**RESPONSE TO REQUEST FOR ADDITIONAL INFORMATION**

**US-APWR Design Certification**

**RAI NO.:** NO. 94-1491 REVISION 1

**SRP SECTION:** 02.05.04 – Stability of Subsurface Materials and Foundations

Figure 1, Reduced Effective Area for Eccentrically Loaded Basemat

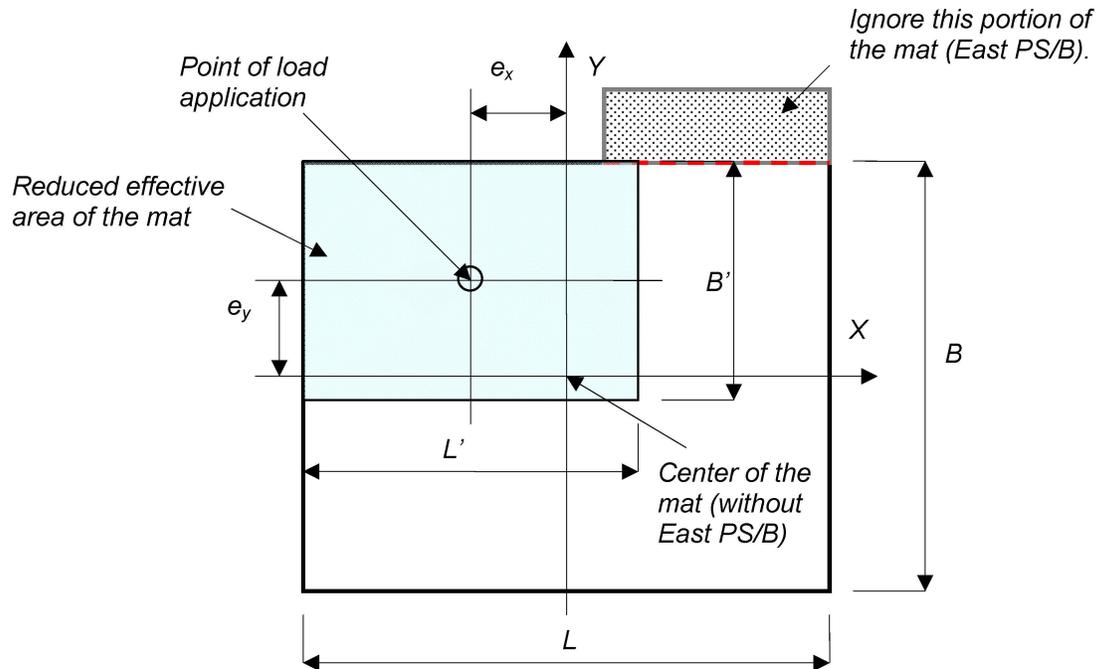
- a) Clarify your use of "average" static and dynamic bearing capacity rather than a minimum value. Please explain how the dynamic bearing pressure was determined.
- b) Clarify why there is not a parameter value for settlement in Tier 1 and a description in Tier 2, Section 2.5.4.

3. For eccentrically loaded footings, a reduced effective area  $B' \times L'$ , within the confines of the physical footing, is used to calculate the bearing pressure demand as shown in Figure 1 below (Reference 1). Note that the irregular basemat area of the R/B complex is transformed into a rectangular area by conservatively removing the base area of the East power source building (PS/B).

In Figure 1:

$$B' = B - 2e_y, \quad L' = L - 2e_x;$$

$$e_x = \frac{M_y}{F_z}, \quad \text{eccentricity in X direction;}$$

$$e_y = \frac{M_x}{F_z}, \quad \text{eccentricity in Y direction;}$$

$M_x$  and  $M_y$  are the overturning moments in the X and Y directions, respectively.
